411 Akard

Neighborhood: Downtown

Program: Retail / Residential

urban design comments 11.21.2014

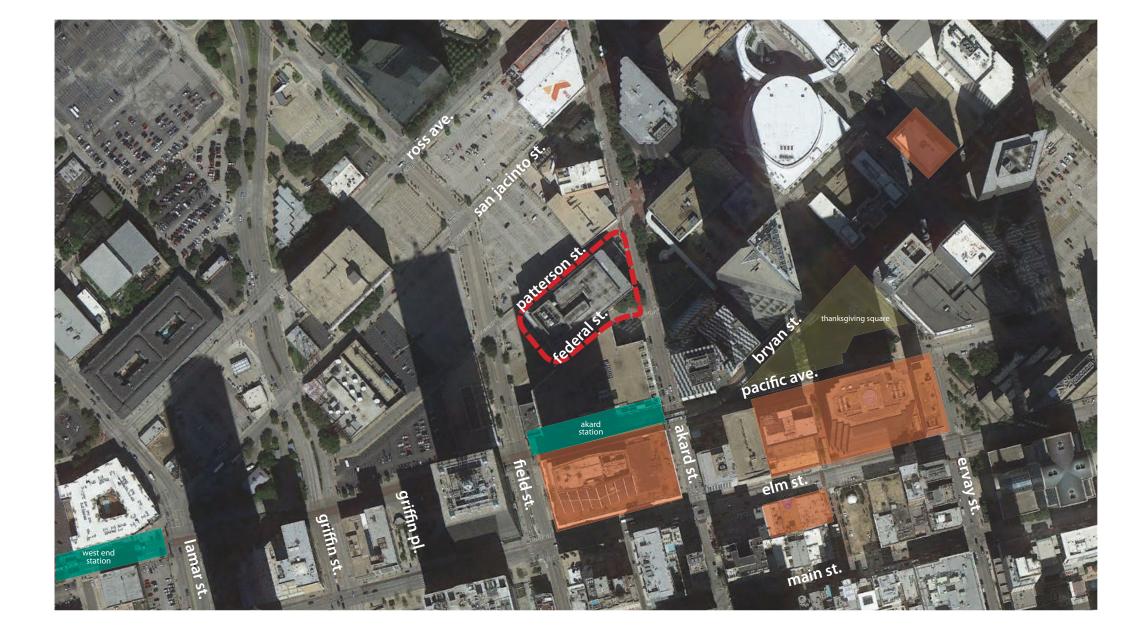
[1] Locate street trees wherever possible along Akard and adjacent building frontages -

Additional street trees are recommended along all sidewalk frontages. Consideration should be made to extending sidewalks along Patterson to accommodate additional street trees between parallel parking stalls.
